Re: WTF NY Lot Line  
Town Project No. 2014-17  
S-B-L: 2-1-42 & 46  
Job No. 13072-WTF

Please be advised that Talcott Engineering has prepared a revised subdivision plan set for the above referenced project. Said plan set has been revised to address the following:

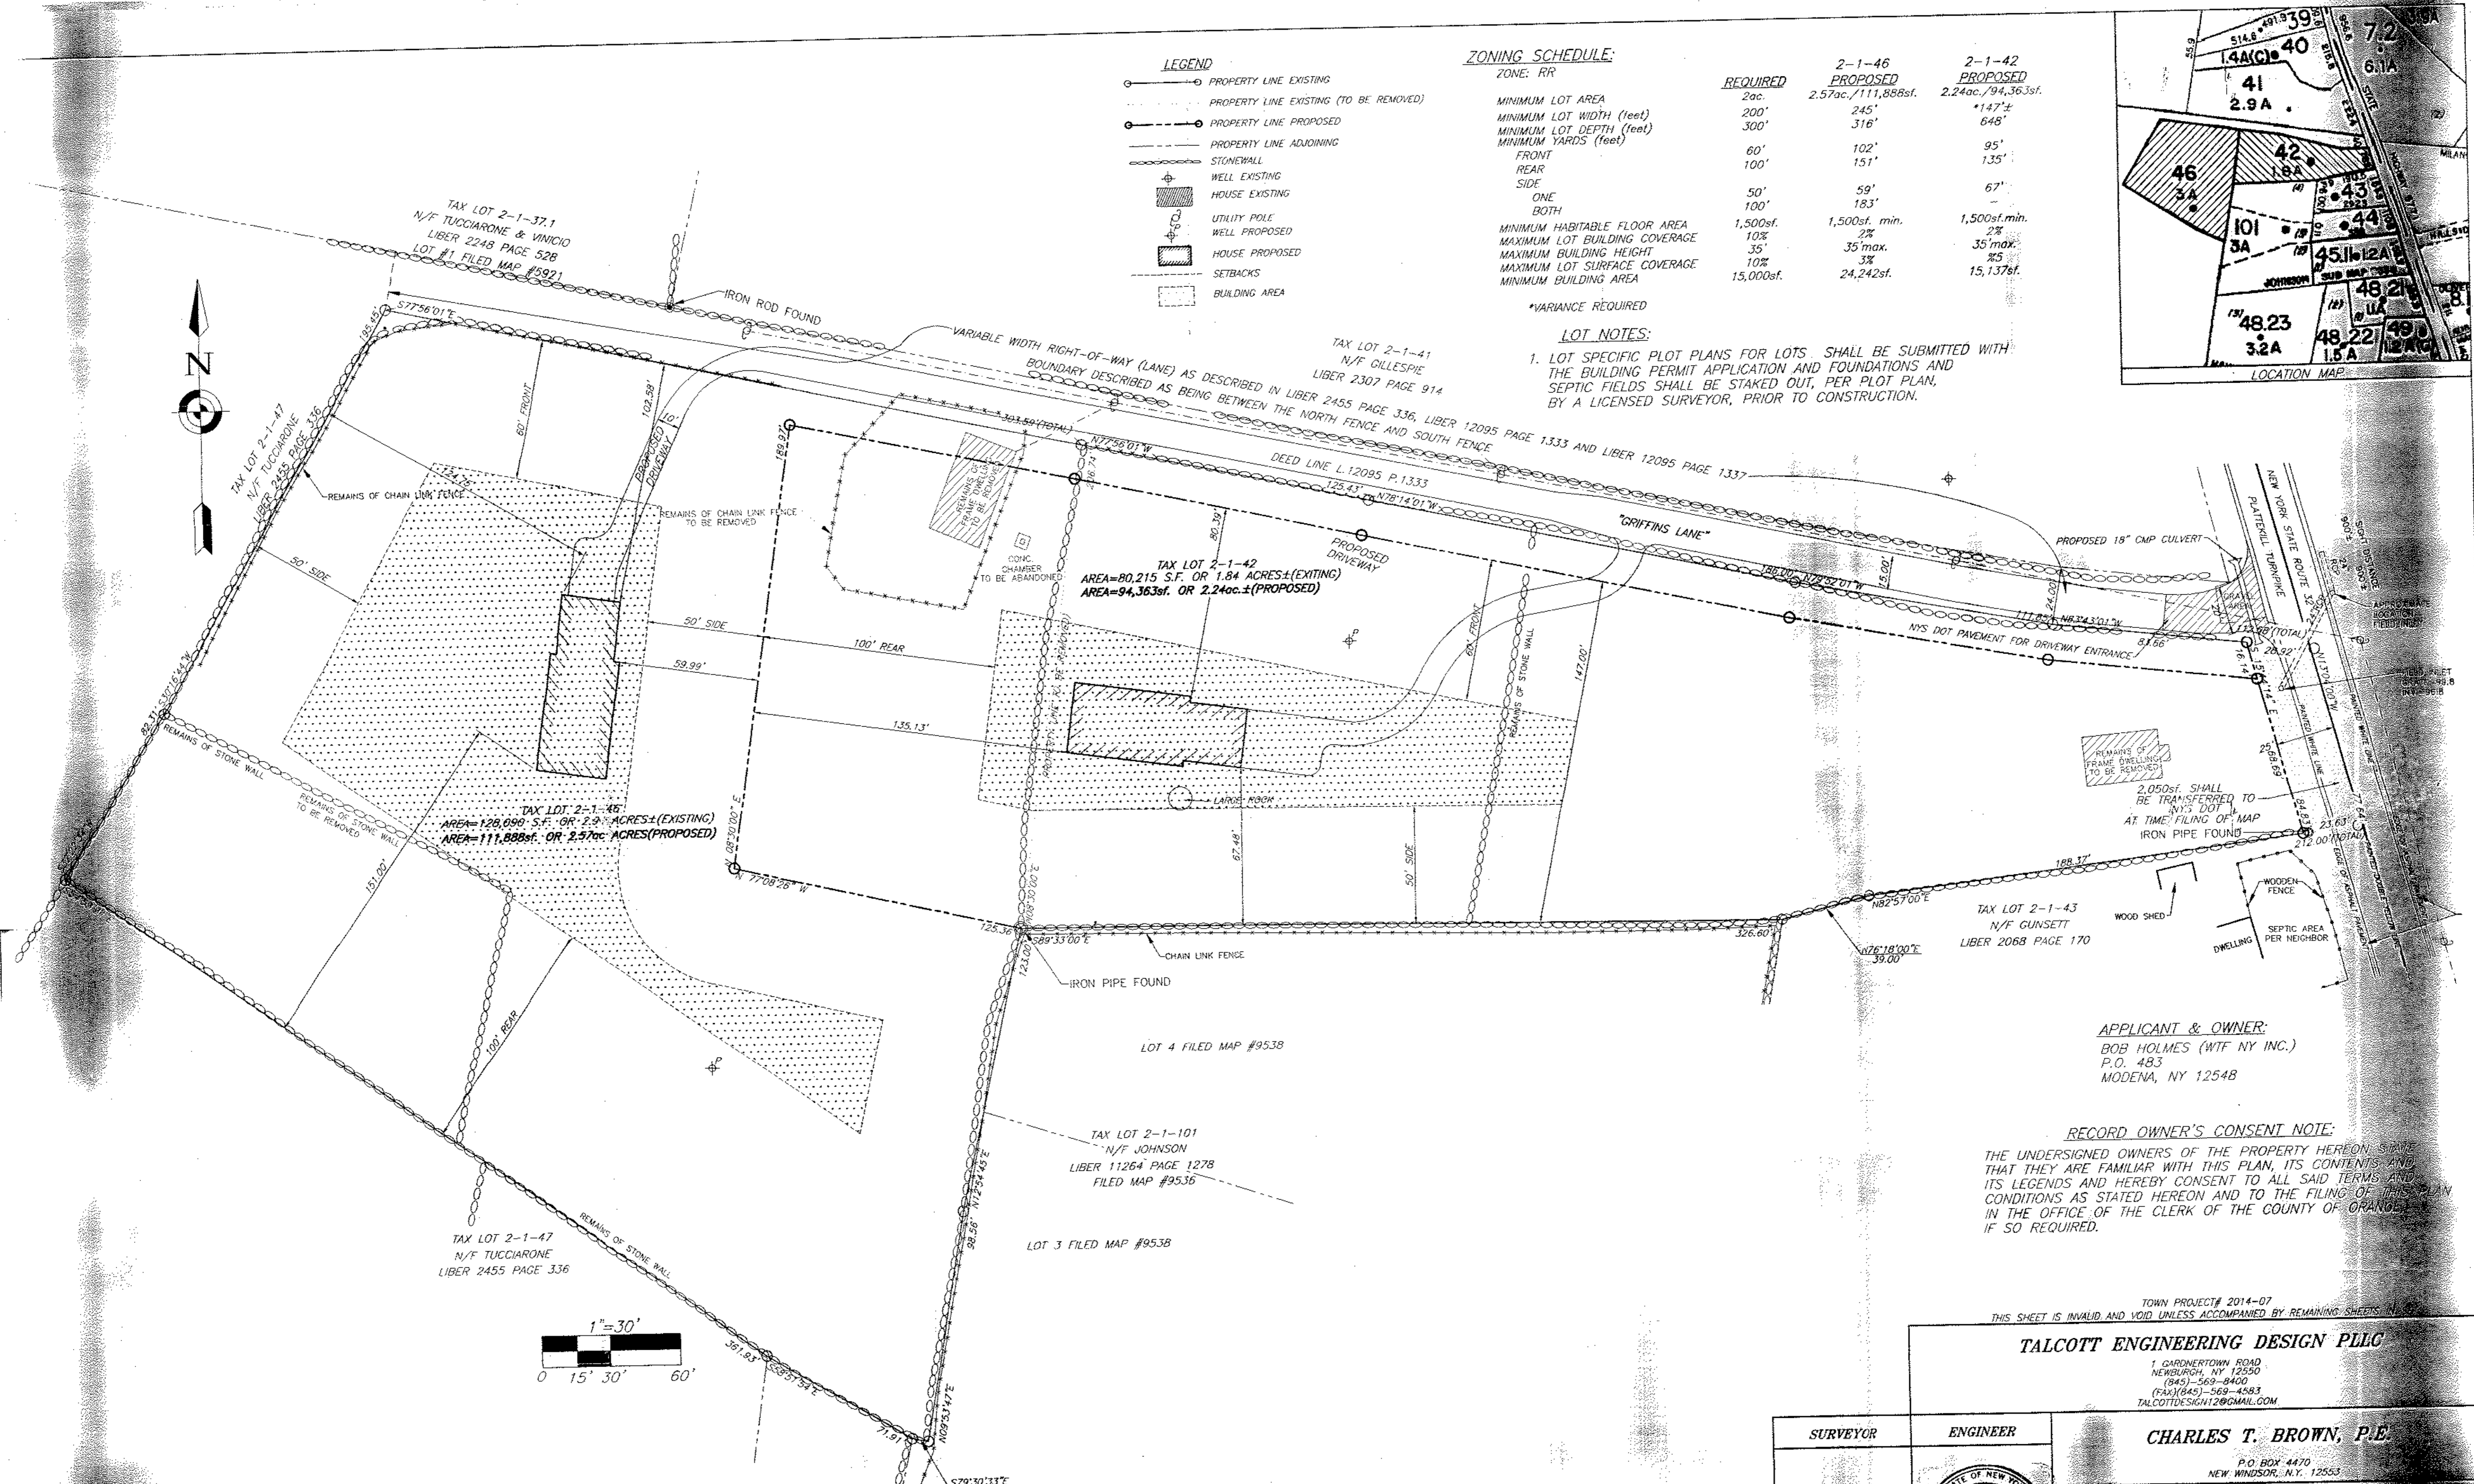
To address Mike Donnelly's Comment;

Per Pat Hines Comments;

1. The lot line change has been revised to give the rear lot (lot 46) a 15' wide "pole" to NYS Route 32 for fee access.

1. The above change modifies the amount of land being transferred and increase the nonconformity of lot width for the front lot (lot 42). We would need a width variance to 145' to achieve the 15,000sf buildable area now required per codes.

2. The buildable area is shown for each lot. Lot 42's area is based on the above.

3. Both lots have rights to use Griffins Lane for access, therefore, the driveways will utilize this Lane. An easement is provided so that Lot 42 can cross the proposed "pole" and access Griffins Lane.

5. We met with the DOT on April 11<sup>th</sup>. Plans now reflect their field comments, including the entrance widening, extent of pavement and adjusted ROW. Site distance was not an issue.
